| **Technical Service Bulletin**: TSB220021 | **Released Date**: 07-Feb-2022 |
| **Mislabeled Thermal Management System Harness** | |

- BES CM0904 EV104B

Figure 1, Thermal Management System Harness Schematic (Pump-side).

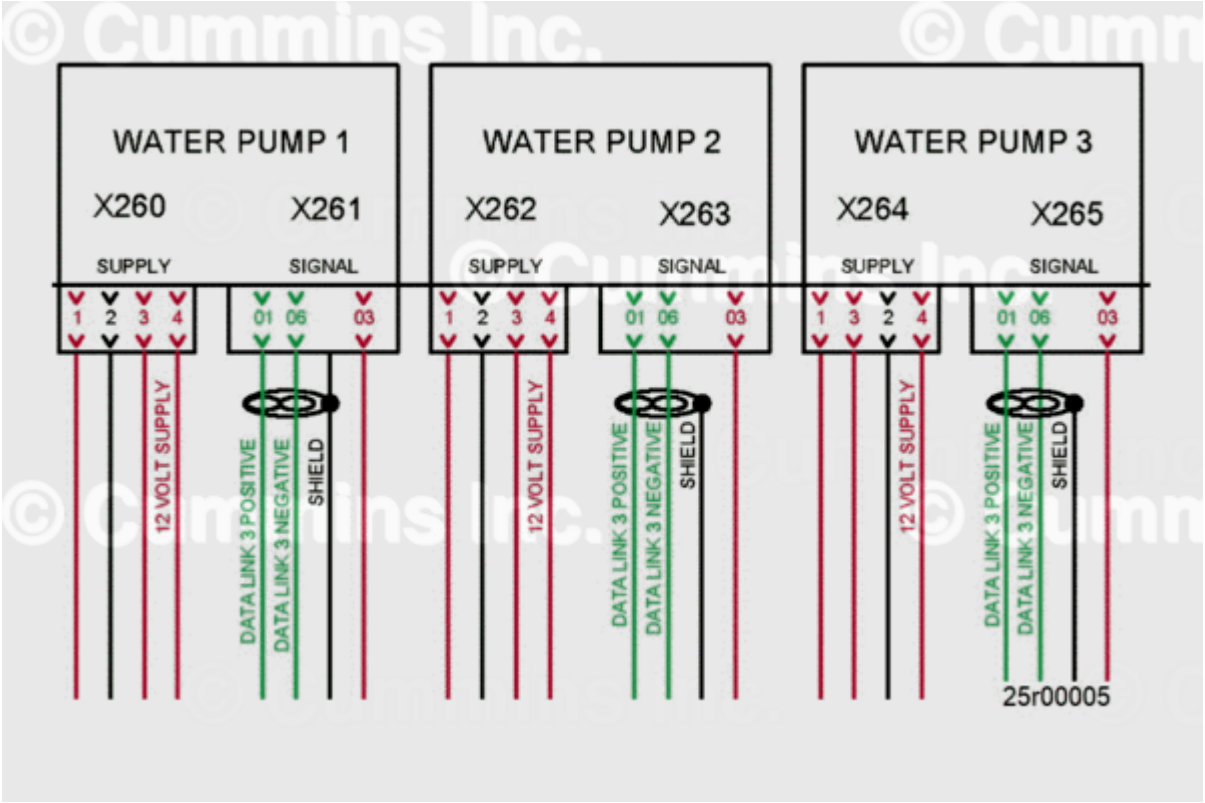
The existing thermal management system harness is labeled incorrectly. See Table 1 for correct labeling.

Figure 2, Example of Mislabeled Power Connector as x265 Which Should Be x264.

| | Mislabeled As | Correct Label |
| Power | x261 | x260 |
| | x263 | x262 |
| | x265 | x264 |
| Supply | x260 | x261 |
| | x262 | x263 |
| | x264 | x265 |
